# Work Order ID 96722

Item Name: Crosstube Fwd

DRAWING NO. D206-667-143	TITLE CROSSTUBE ASS'Y (206L HIGH FWD)	REV. C	<b>DART AEROSPACE LTD ENGINEERING ORDER</b>		D.E.O. NO. D206-667-143-C-1	SHEET NO. SHEET 1 OF 1	SCALE NTS
DRAWN 97	CHECKED ASS	MFG. APPR. [Signature]	APPROVED [Signature]		DE APPR. [Signature]		
DATE 11.07.15	DATE 11.07.20	DATE 11.07.21	DATE 11/07/21		DATE 11.07.21

DRAWING NO. D206-667-143	TITLE CROSSTUBE ASS'Y (206L HIGH FWD)	REV. C	DART AEROSPACE LTD ENGINEERING ORDER		D.E.O. NO. D206-667-143-C-2	SHEET NO. SHEET 1 OF 1	SCALE NTS
DRAWN AJS	CHECKED	MFG. APPR.	APPROVED		DE APPR.		
DATE 12.08.02	DATE 12.08.02	DATE 12.08.02	DATE 12.08.02		DATE 12.08.02

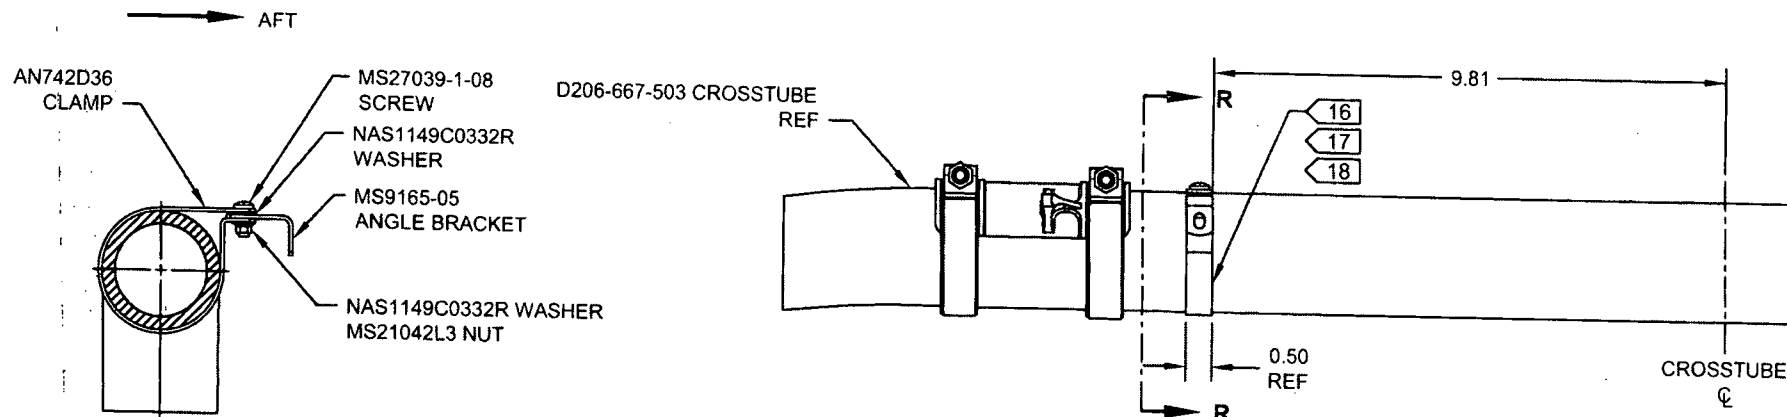
ADD ELECTRICAL GROUNDING STRAP

ADD
